Access Compliance Report

Public Rights-of-Way

Intersection ID: 48408	Main Street: ERNIE_DR	Cross Street: BRYN_ATHYN_CT	Location: SW
ADA ID: 8972FFDFD18E	Ramp Type: PerpDiag	Initial Pass/Fail: Pass	Overall Compliance: No
Severity Score: 22.75			
Codes/Mitigation Info/Possible Solution		Field Measurements/Component Compliance

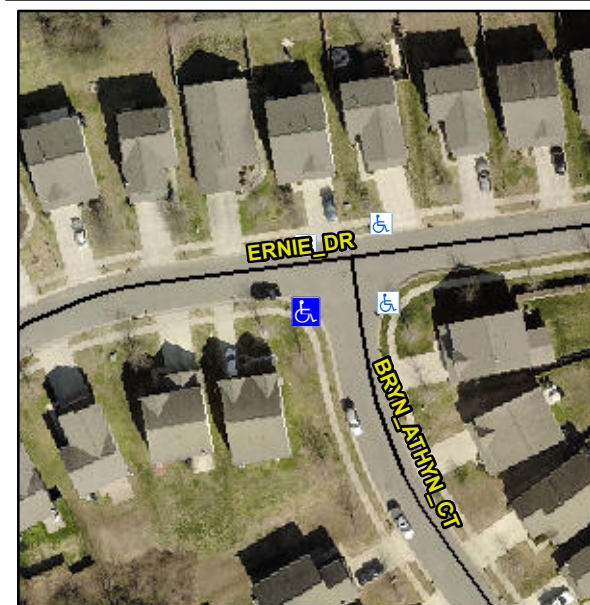
Not Found, R304.5.3, R305.1.4, R305.2, R302.7.2, R304.5.4

Compliance	Description	Data	Compliance	Description	Data
N/A	Ramp Length (in)	48.0	Yes	Ramp Slope (%)	7.3
Yes	Ramp Width (in)	48.0	No	Ramp XSlope (%)	2.7
N/A	Flare Type LT	Sloped	N/A	Flare Type RT	N/A
N/A	Flare Slope LT (%)	5.2	N/A	Flare Slope RT (%)	8.6
N/A	Flare Traversable LT?	No	N/A	Flare Traversable RT?	No
Yes	Landing Length (in)	48.0	Yes	DWS Provided?	Yes
Yes	Landing Width (in)	48.0	Yes	DWS Contrast?	Yes
Yes	Landing Slope (%)	0.7	Yes	DWS Length (in)	24.0
No	Landing X Slope (%)	3.1	No	DWS Full Width?	No
N/A	Landing Curb? (Y/N)	No	No	DWS Offset (in)	3.0
N/A	Shared Landing?	No			
Yes	Gutter Ponding?	No	No	Gutter Slope (%)	10.3
No	Gutter Lip Ht (in)	1.0	Yes	Gutter X Slope (%)	0.1
N/A	Painted X Walk1?	No	N/A	Painted X Walk2?	No
	X Walk 1 Direction	To E		X Walk 2 Direction	To N
N/A	X Walk 1 Width (in)	N/A	N/A	X Walk 2 Width (in)	N/A
	X Walk 1 Slope (%)	1.4		X Walk 2 Slope (%)	5.9
	X Walk 1 X Slope (%)	3.6		X Walk 2 X Slope (%)	1.5

Remove & Replace Curb Ramp With Two New Directional Ramps or Equivalent. Remove & Replace Gutter.
